SUBJECT: LETTER OF NOTIFICATION FOR A 10CFR21 REPORTABLE
CONDITION

Following our initial contact, Weed Instrument Company, Inc. has completed its evaluation of a possible defect in pressure transmitters assembled and sold by Weed Instrument Company.

Reference: Foxboro Model No. N-E13DM-IHM2
or Spare Part No. N0141FN

RE: Weed Model N-E11 & N-E13 Pressure/DP Transmitters
10CFR21 Notification

Figure No. 1

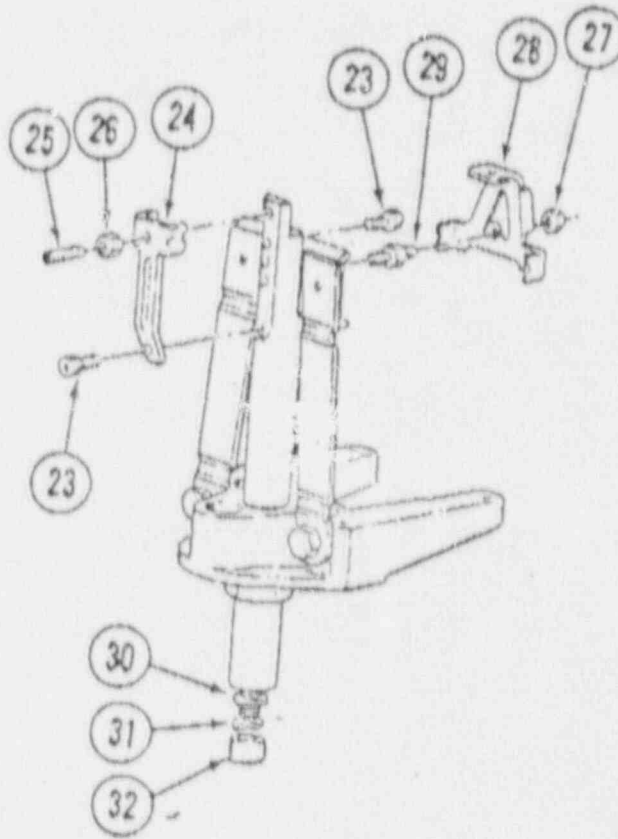
In compliance with 10CFR Part 21.21(a)(1) (ii), this letter is to notify you that we may have shipped you either a transmitter with an improperly processed part and/or the part itself. The subject part is Part No. N0141FN, a bracket, and is identified as number 24 in the attached Figure No. 1. The bracket is located in the transmitter topworks at the top of the force bar assembly and provides topworks static alignment and overrange protection. In August of 1989 the bracket material was changed to a 410SS, which requires a two step heat treating process, instead of a single step process, for proper material characteristics. The correct process change was not implemented until Jan.-Feb. 1990. Single step heat treatment of 410SS allows cracks to form near the bracket mounting hole and from which the cracks will continue to propagate, thus weakening the bracket. This discrepancy was discovered only very recently. Weakening brackets may cause one of the following to occur:

- a. Zero Drift and/or Span Drift in the downscale direction
- b. Static Alignment Errors Unable to Realign (DP's only)
- c. Excessive Calibration Non-linearity (>1%) Zero or Elev/Supp Ranges
- d. Inability to adjust from a Zero Based Range to a Suppressed Range Calibration (Using an Elev/Supp Bias Kit)
- e. Greater than normal Overrange Errors

Visual inspection will not reveal the existence of cracks because of bracket painting but different bracket finishes do identify suspected or faulty processed brackets. Unfinished/unpainted brackets and brackets with a "Gray" painted finish must be replaced. Brackets with a "Silvery" finish similar to the finish on the "Forcemotor" are correctly processed and replacement is not necessary.

Thus, transmitter and spare part purchases of the bracket after August 1989 may contain the faulty bracket that requires replacement.

Brackets, Part No. N0141FN, with replacement instructions will be provided free of charge to all users who have the identified faulty transmitters or spare parts. If you have purchased either transmitters or spare parts from The Foxboro Company, you will find attached a listing by serial number and tag number identifying the quantity of each item purchased. This information will help you in ordering replacement parts. Please order these parts through the normal ordering procedure. If there is no attachment then our records do not indicate that you have purchased any of these items and this letter is for your information only.

Use of applicable Foxboro Master Instructions (MI's) will be required to properly align the specific transmitter after bracket installation. It is recommended that only personnel trained in Foxboro Transmitter servicing should perform bracket replacement and transmitter re-alignment. Replacement brackets 24 include screw 25 and locking nut 26 as in Figure No. 1, attached. The mounting screw 23 can be re-used for bracket replacement.
